MTL-53-05

REVISION TRANSMITTAL

FUSELAGE - FILLER SHIM OR FASTENER INSTALLATION AT FUSELAGE STATION 221

MODEL	SERIAL NUMBERS	
B300	FL-1237 thru FL-1295, FL-1297, FL-1298	
B300C	FM-99 thru FM-106

Figure 1. Shim and Fastener Location (Sheet 1)

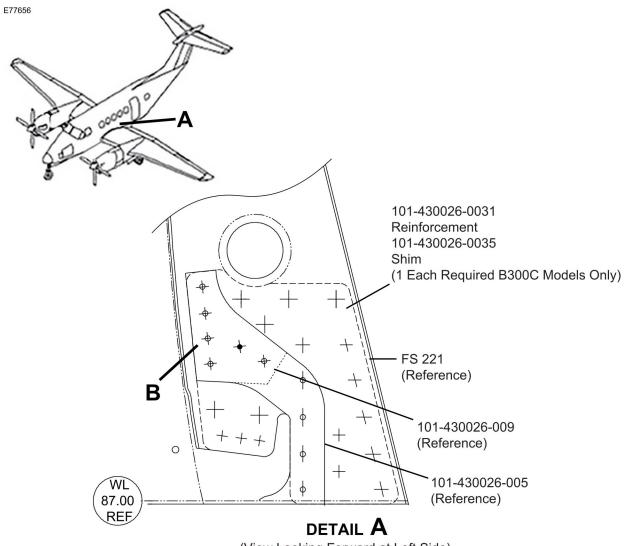
- A. Inserted Caution statement under Step 4. B.
- B. Inserted Step 4. C.
- C. Corrected and updated dimensions on Figure 1 Sheet 2.

NOTE: The location of the missing fasteners might be different for each B300.
